VICTORIAN CIVIL AND ADMINISTRATIVE TRIBUNAL

VCAT REFERENCE NO. P850/2022
PERMIT APPLICATION NO.TPA/52274

APPLICANTS	John Katsis, Patawinee Ally Yooyaem-Katsis & Others
RESPONSIBLE AUTHORITY	Monash City Council
REFERRAL AUTHORITY	Melbourne Water
SUBJECT LAND	Units 1, 2, 3 and Common Property, 19 Burton Avenue, CLAYTON VIC 3168
DATE OF HEARING	13 February 2023
DATE OF INTERIM ORDER	14 February 2023
DATE OF ORDER	17 April 2023
CITATION	Katsis v Monash CC [2023] VCAT 332

ORDER

Figure 1: Proposed street elevation, VCAT Plans in response to Interim Order.

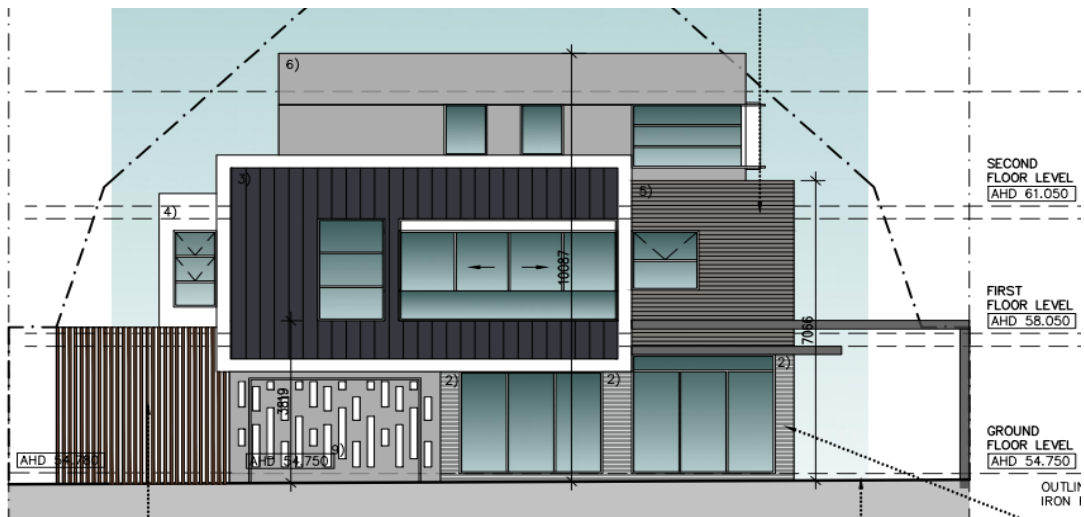
- The waste collection room continues to take up a prime position at the front of the site. It continues to sit forward of the balance of the ground floor layout, and in doing so, represents one's first impression of the development. In Council's view, this is an element that should be sited to the rear of the site, and not given prime position in the frontage. We remind the Tribunal of the schedule 3 to the Residential Growth Zone seeking "high quality design and finish".

- The waste collection room will result in odours and noise filtering to the public realm at street level, with this room setback just 5.3m from the footpath. In Council's view, this is contrary to the urban design principles at Clauses 15.01 of the Monash Planning Scheme that seek "to create urban environments that are....healthy...and enjoyable..".

- 7 The key change to the development is the presentation to the street. As detailed above, the ground floor room has been increased in size to 7 metres, the waste room has been reduced in size and treated with timber battens to the façade and the garage door has been further set back from the street.

- 8 In response to the proposed changes to the street presentation, as detailed earlier, Council raised concern with the location and design of the waste room and the impact of the waste room from a health perspective directing me to consider the ‘the urban design principles at Clauses 15.01 of the Monash Planning Scheme (**planning scheme**) that seek ‘to create urban environments that are....healthy...and enjoyable..’.

- 11 The street frontage also comprises of the garage door and waste room. The waste room has its frontage to Burton Avenue, is set off the side boundary by 1 metre and setback from Burton Avenue by 5.305 metres. In response to Council's concerns, the applicant suggested that the waste room could be set back to 5.7 metres from the street, noting that it was their view that the change was not warranted.

- 12 Whilst the increase of the waste room to a setback to 5.7 metres is a minor change, I will require it. The increase even though small, will help to provide an area for meaningful landscaping and the increase further reduces the visual impact of the room to the street. I further make the observation that the waste room will appear as a room with timber slats, not dissimilar to examples of developments provided at the hearing and within Burton Avenue. It is my view that the passer-by will not read the room as a waste room. It is also my view that the success of the presentation to the street will also be dependent on the material used. The plans detail 'Feature Timber Battens'. A condition has been included requiring the detail of the colour, width and spacing of the battens to ensure a high quality finish. The responsible authority should ensure that the materials used are of a high quality, as indicated on the plans.

- 13 Overall, I find the presentation acceptable. It balances the objectives of the planning scheme seeking diversity of housing and high quality design. The presentation, as amended, is in part an active living space (dwelling 1 sitting/home office), a garage door and a waste room. Having a single garage door reduces the level of hard pavement to the street whilst providing for a maximum area for landscaping. The landscaping plan details the retention of an existing tree located in front of the ground floor room and space for a garden area in front of the waste room. The responsible authority should further ensure that the landscaping in the front setback is meaningful. Landscaping will soften the visual impact of the overall development to the street.

- (g) The southernmost parking space deleted and the bin room setback 1m from the side boundary and 5.7 metres from the front boundary as detailed in the VCAT plans dated 24 February 2023.
